L.3 Bylaws for 3080, 3082 and 3090 Washington Avenue: Rezoning Application No. 00714

To: Council **Date:** March 4, 2021
From: Karen Hoese, Director, Sustainable Planning and Community Development
Subject: Update Report for Rezoning Application No. 00714 and Associated Official Community Plan Amendment and Development Permit Application No. 000566 for 3080, 3082 and 3090 Washington Avenue

Project:
WASHINGTON
TOWNHOUSES
3080-3090
WASHINGTON AVE.

Figure 2. Proposed Grades for the Doric Connector

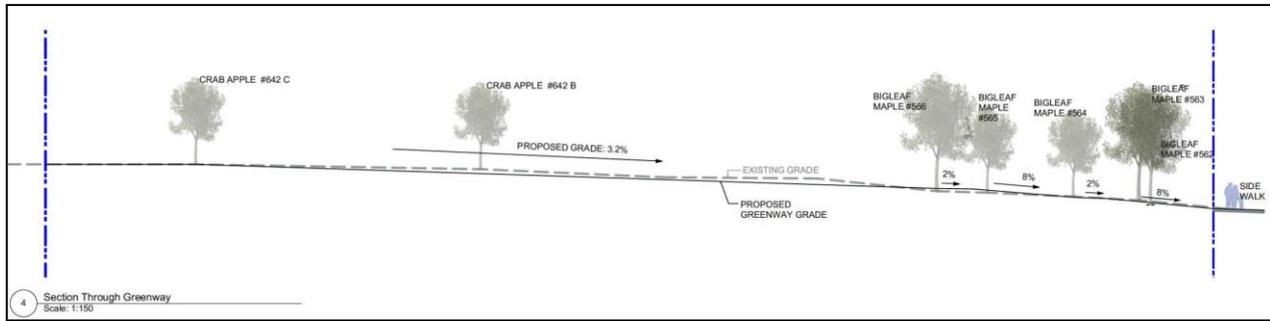
This proposed realignment will also allow for an additional landscape buffer between the Doric Connector and the neighbouring property to the north. The applicant is proposing to add some native understory plantings to further enhance this landscaped area, which would be maintained by the City once the area is planted. Summarized in the table below are the updated annual maintenance costs that would be incurred by the City to care for the trees, grass boulevard and irrigation system, and the native understory plantings.

Figure 3. Proposed Elevations for Building H (Building E is the same)

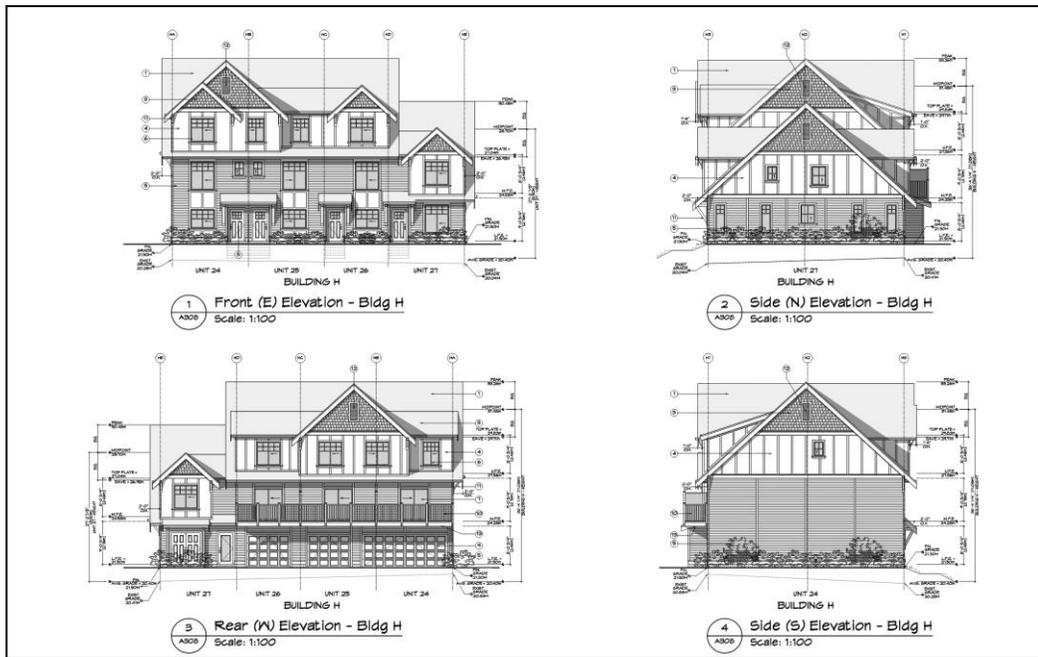
Council requested that the applicant consider revisions to the design of the attached dwellings on the north and/or south property lines to achieve a more sensitive transition to, and minimize impacts on, the adjacent neighbours. In response to this request, the applicant introduced a building transition within the design of Buildings E and H by reducing the heights of the end units (units #16 and 27) from three to two storeys (refer to Figures 1 and 3). The applicant has indicated in their letter dated November 16, 2020 that this revision would reduce shadow impacts and potentially alleviate some privacy and overlook concerns. Building J, also located on the north side, is currently two storeys.

Figure 4. Site Cross-Section

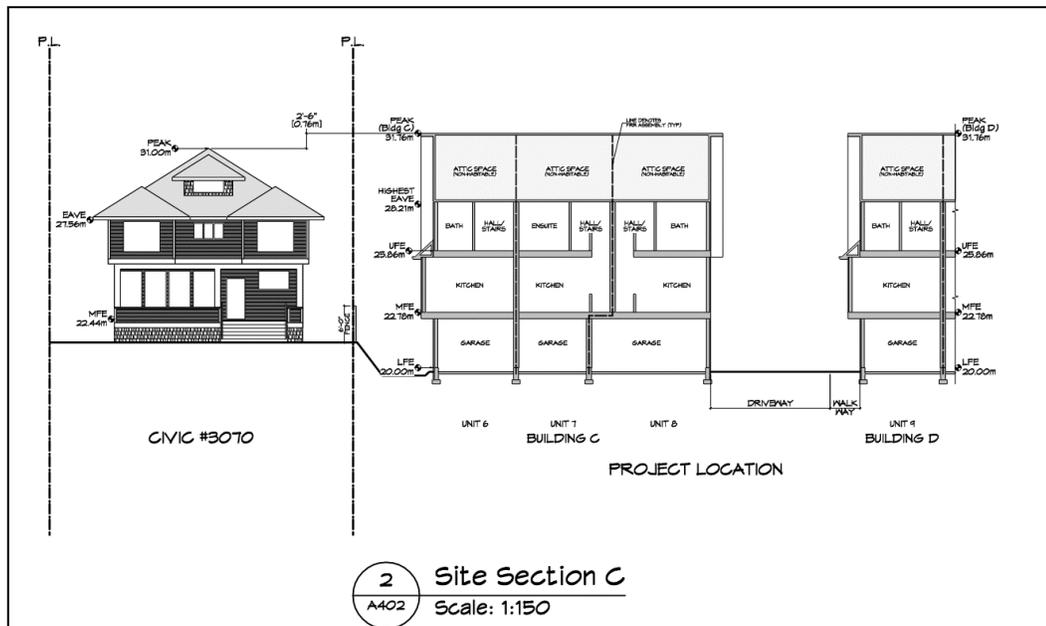
The applicant reviewed building transition along the south side of the property and did not reduce the building heights of Buildings C and F, which are currently three storeys. The applicant provided a cross-section demonstrating the relationship between Building C and the existing house on the adjacent property at 3070 Washington Avenue and confirmed that Building C would be 0.76m (2.6ft) taller than the existing house, which the applicant feels is an adequate building transition (refer to Figure 4). The applicant did not reduce the building height of Building F since it would be adjacent to an existing driveway on the neighbouring property.

1 Streetscape - Washington Ave
A401 Scale: 1:225

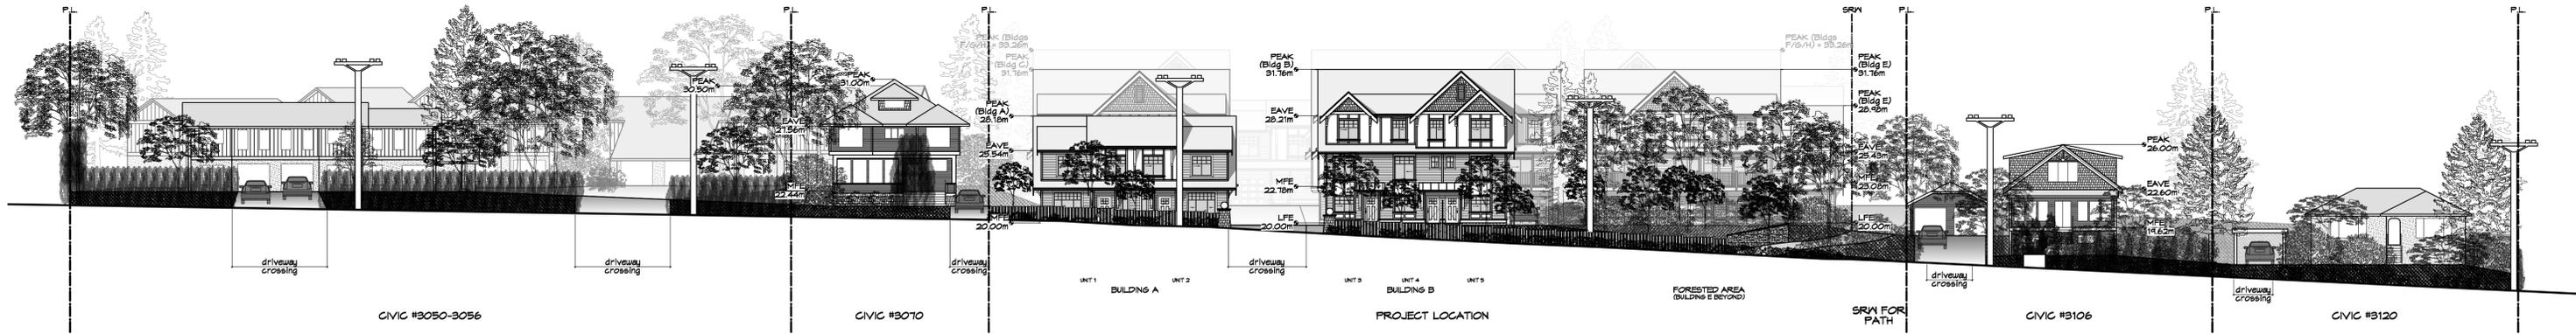
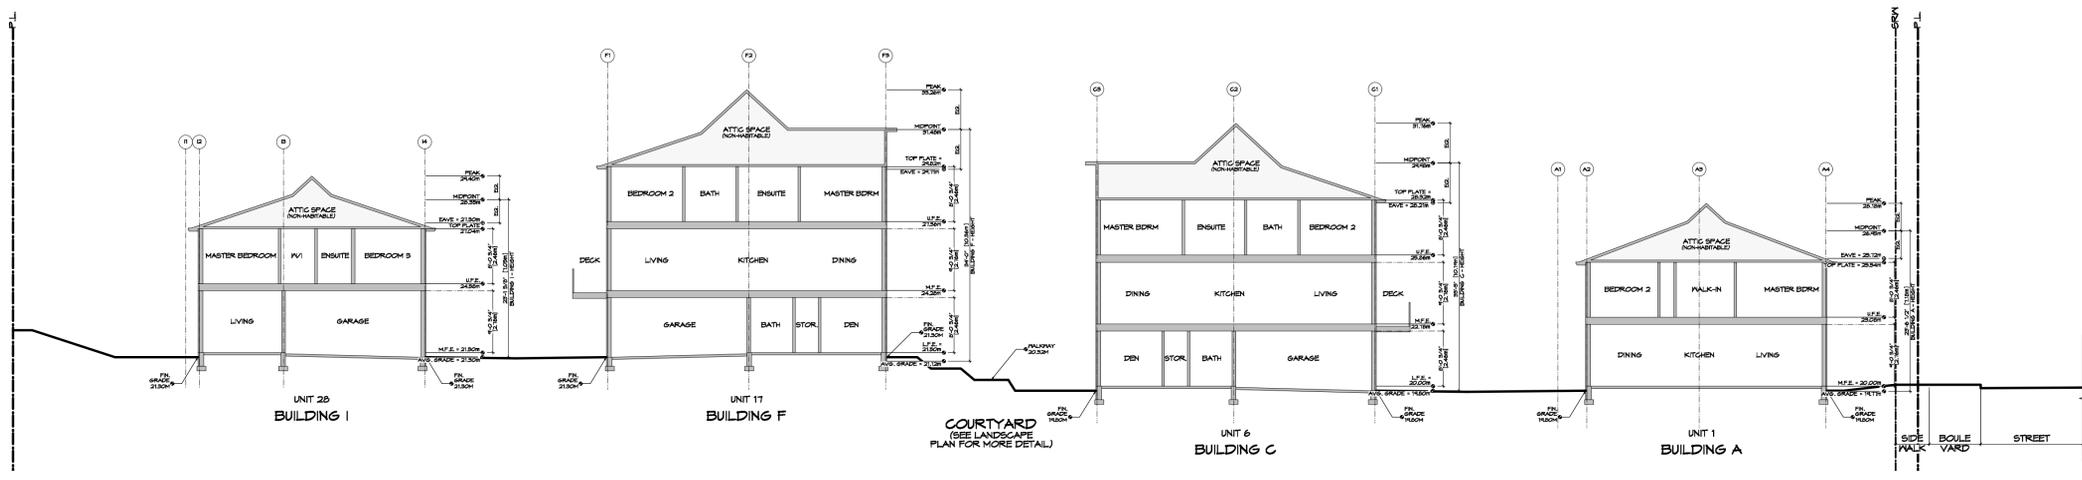
c. Streetscape (Sheet A-401) *NOTE: Setbacks are very different and not apparent here.*

1 Site Section B
A402 Scale: 1:150

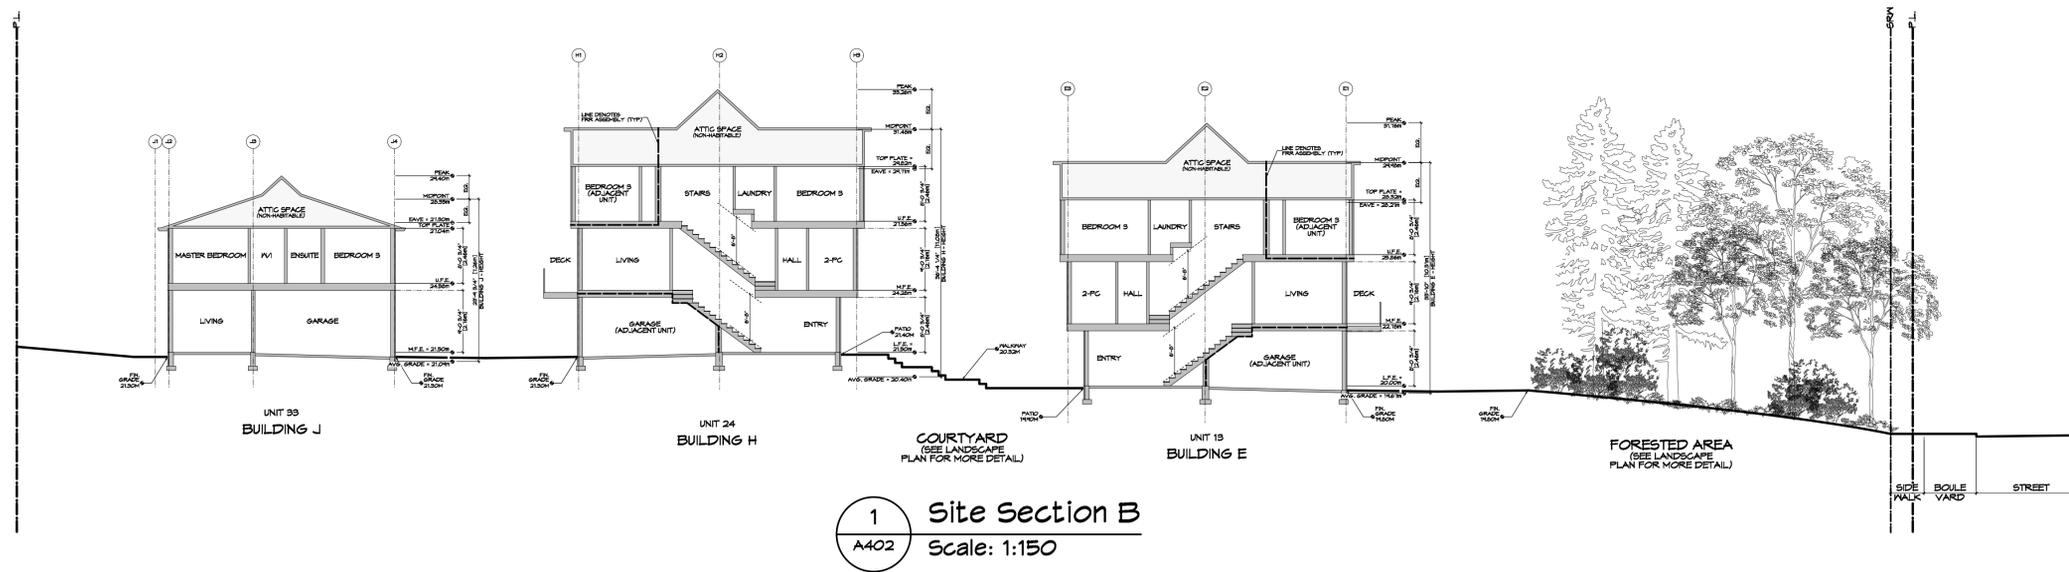
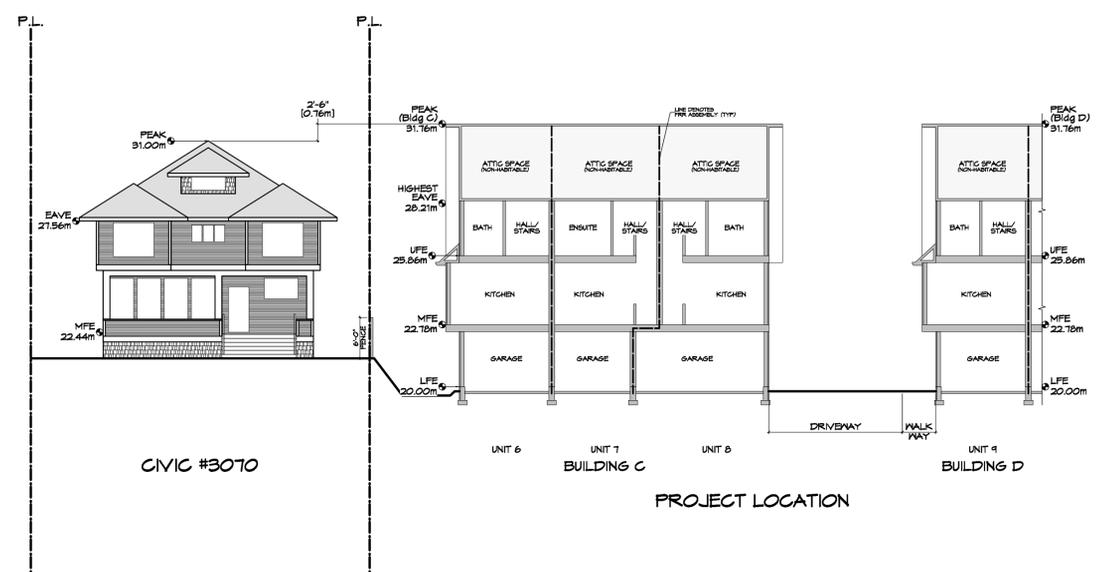
- b. Using 3070 Washington Ave, the tallest home on the west side of Washington Ave, as a benchmark for height, is not appropriate (Sheet A-402 of Curate plans). The house at 3070 is set back 70-feet from the sidewalk. Building B of the development, as proposed, is both taller and only 12-feet back from the sidewalk. This would dramatically change the feel of the street for pedestrians, cyclists, drivers and residents.

Sheet:
A
501

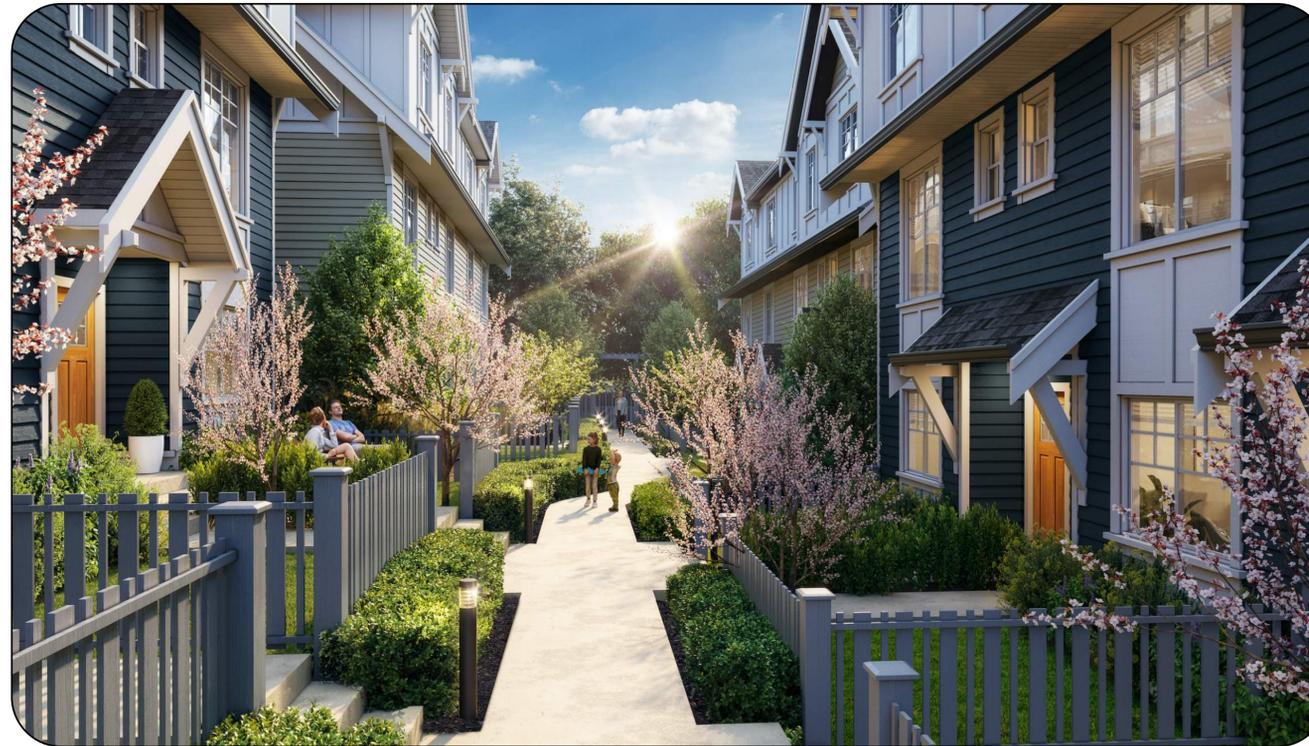
Rendering (Sheet A-501) *NOTE: the rendering below purposely does not show the existing, adjacent buildings and the development's relationship to them.*

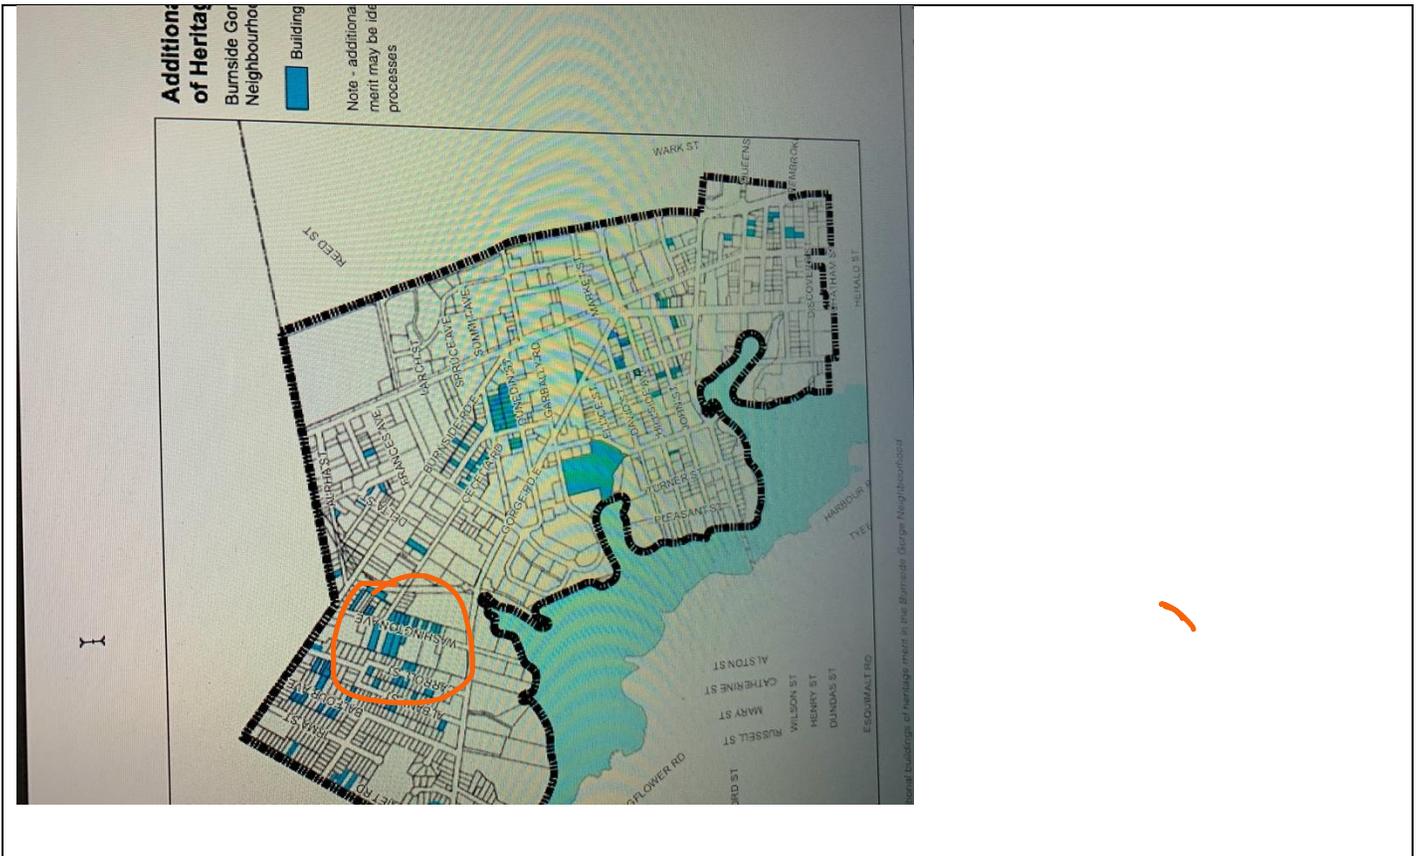
Concern: Additional Buildings of Heritage Merit are identified as being in the very area slated for development by this project. The lots on Washington are identified in the picture below taken from the Burnside Gorge Neighbourhood Plan.
